Lenord & Bauer Gel 823XXX

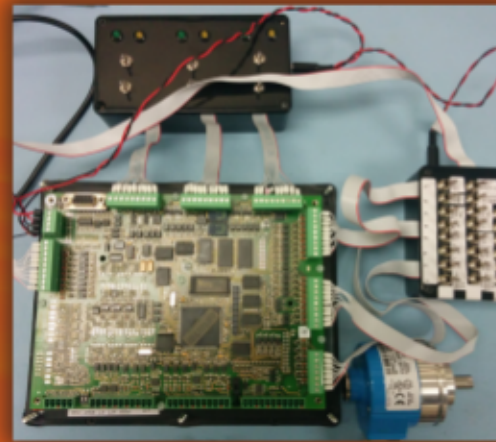
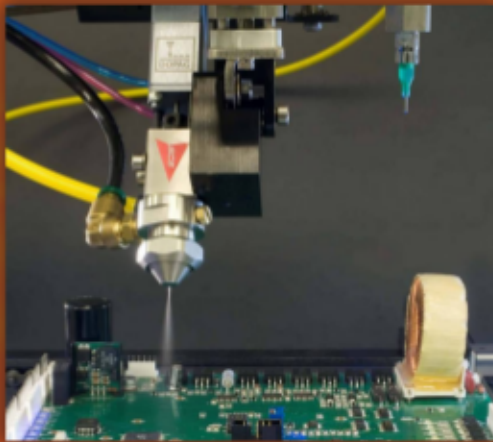
- Errors introduced under specific environmental conditions (High Humidity)
- Solutions: Conformal coating now added as standard!

- Prone to Communication and timeout, noise and transient signal issues
- Solution: Circuit Enhancements use of Military spec Opto-couplers
- Improved Protection and higher electrical power rating
